Building Performance Inspection Including Moisture and Mold Assessment Harold Kelly Murphy Residence, Montgomery, AL

Report completed by: Francis Conlin, PE, CMR Site investigations: October 24, 2007 and December 4, 2007 Report Date: December 28, 2007

In Reference to Harold Kelly Murphy v. Southern Homes

Figure 1. Mean Dew Point Montgomery, Alabama Summer 2004 -2007

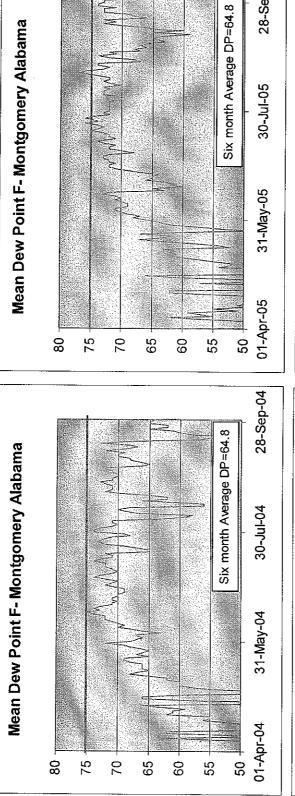
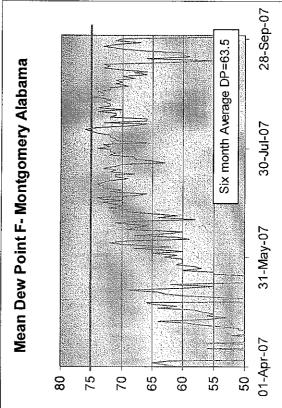
The HH expert has stated that during the periods from May to September that the outside dew points are routinely above 75°F.³ In addition, the illustration used in the (HHR 5-22-06) Page 3, Figures 1 & 2 shows an outside dew point of 78°F; whereas in fact, the mean dew point in Montgomery, AL has NEVER reached 78°F in the past 4 years, and the maximum dew point reached 78°F once in 2007 and twice in 2006.

The claim that 75°F dew points are commonly reached is highly exaggerated.

The mean dew point temperature (not maximum dew point temperature) is the appropriate term to describe climate effects on wall cavities, regardless – even maximum dew point does not exceed 75°F to the degree claimed.

Figure 2. HHR 5-22-06 (*) Sample Locations

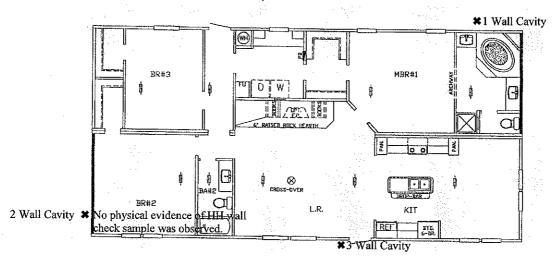
Typically HH wall cavity sampling locations are obvious and indicated by a pair of holes in the wall that have been sealed with silicon-like white caulk. No evidence of a wall sample was located in the area that HH identifies in his HHR 5-22-06 report as sample site location "End br w/c" (Denotes as * 2 Wall cavity in Figure 1); however a laboratory sample was apparently submitted by Healthy Homes and reported by HH's Lab.

■5 Crawlspace Air Figure 3. MS 10-24-07 (■) Sample Locations ■3Outside Air Back Visual Wall Cavity ■10 ■6 Visual Wall Cavity RAISED ROCK HEARTH 8 ■1 Air Kitchen BR#2 L.R. KIT 9 Visual ■ Wall Cavit SYD. ■7 Visual Wall Cavity ■8 Visual Wall Cavity

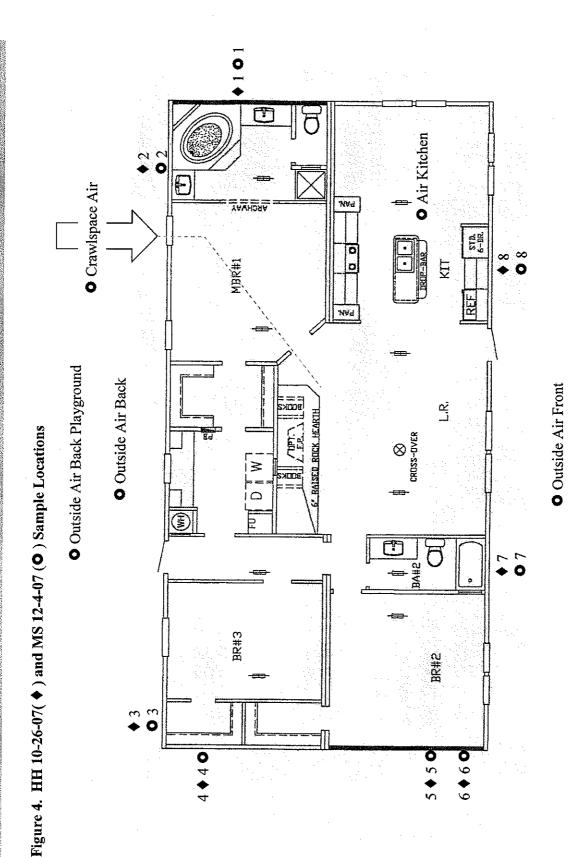
Three of the four inspections sites revealed wallboard, wood framing and batt insulation in likenew, pristine condition with no visible fungal staining. Photographs of these sites support these observations (Photos 2-4). It should be noted that some spots (freckles) are part of the normal appearance of these gypsum wallboards.

One inspection site from the master bathroom rear wall showed some apparent mold staining (Sample site MS 10-25-07 ■6 Visual Wall Cavity & Photos 5-7). The cause of this staining is apparently a previous plumbing flood in the bathroom. Saturation lines in the wall that are commonly associated with flooding are observed within the wall cavity: also, the homeowner reported a sinkplumbing failure directly adjacent to the stained wall cavity area. This wall stud bay adjacent to the sink was reported as soft; however, this wall had been previously impacted resulting in a "square shaped" impact indention that broke the board and paper backing. An additional source of moisture in this area is rainwater and hose water entry from the landscaping and bottom plastic that is torn in this area.
